Construction Report

St. Vrain Mill Foundation Stabilization

APPENDIX A
REDLINED DRAWINGS

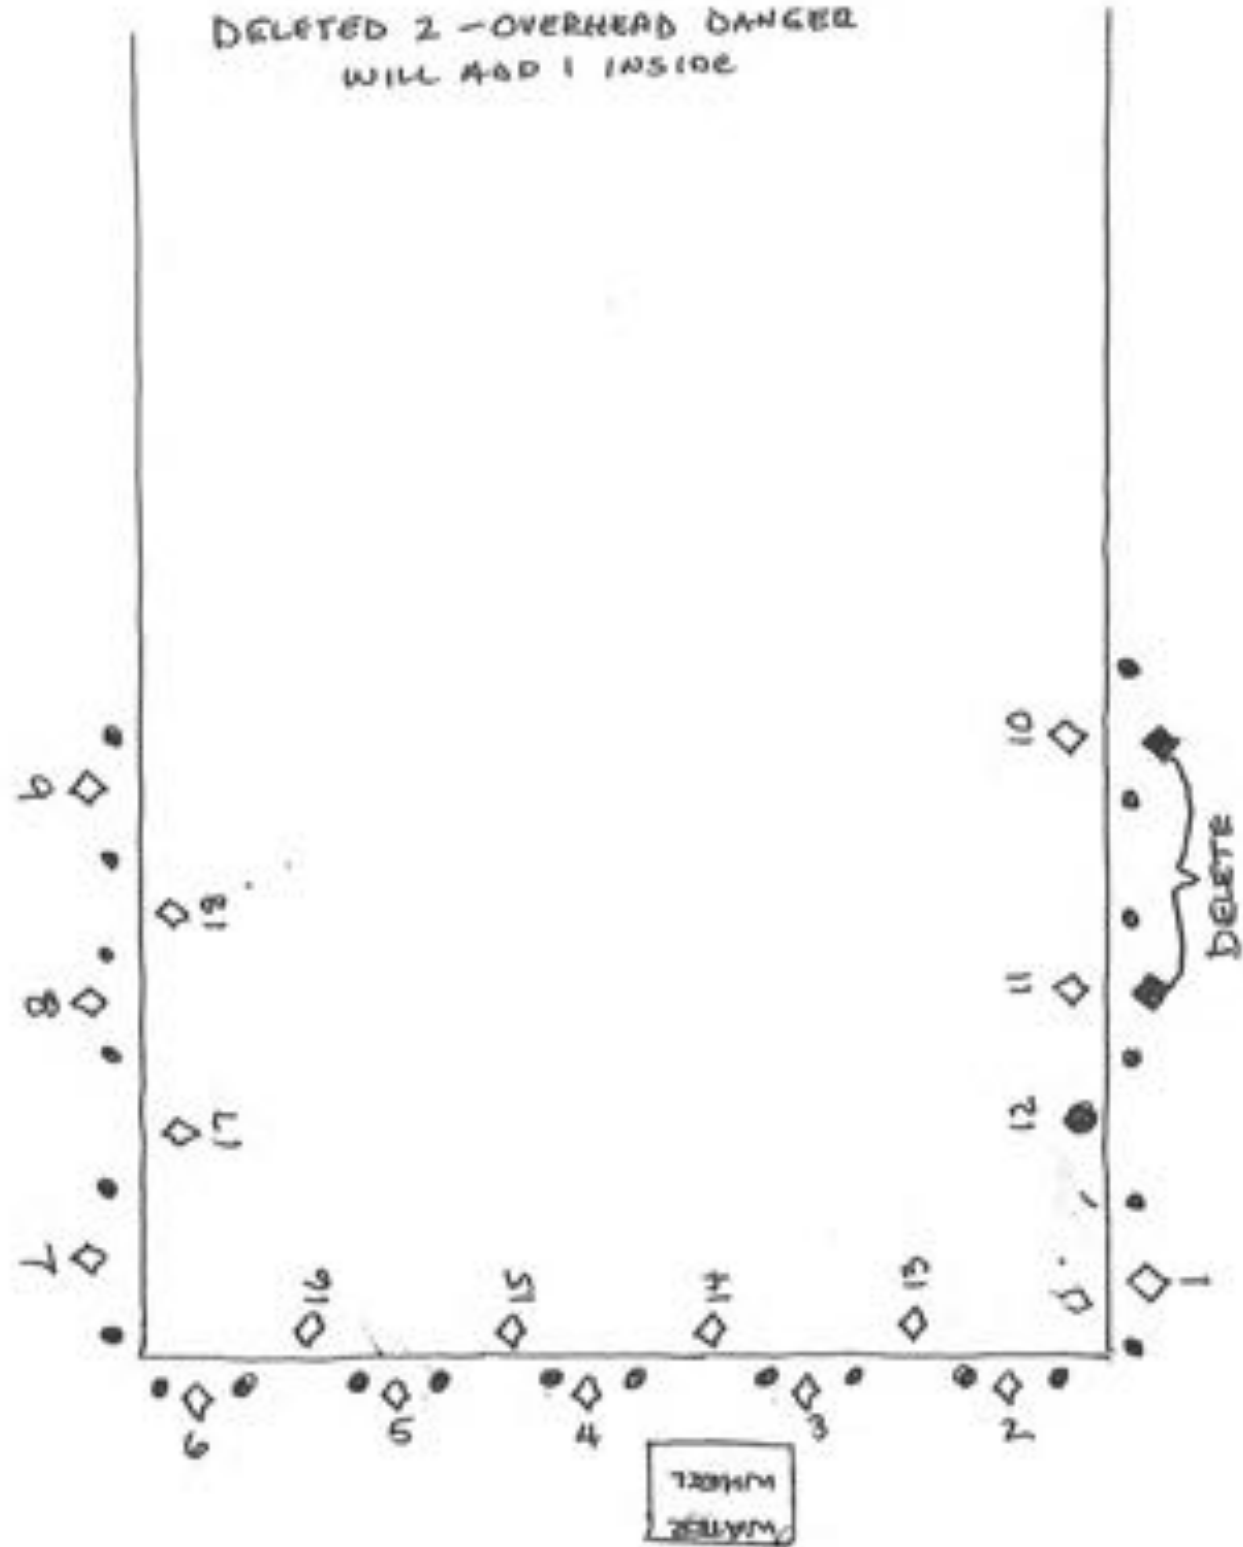
DELETED 2 - OVERHEAD DANGER
WILL ADD 1 INSIDE

- The two compaction grout locations furthest south on the outside of the west wall were removed due to overhead hazards at these locations. Loose masonry rock was observed above these two locations making the area unsafe to work in.
- An additional compaction grout location was added to the inside of the building (hole #11) to partially compensate for the removed locations in this general area.
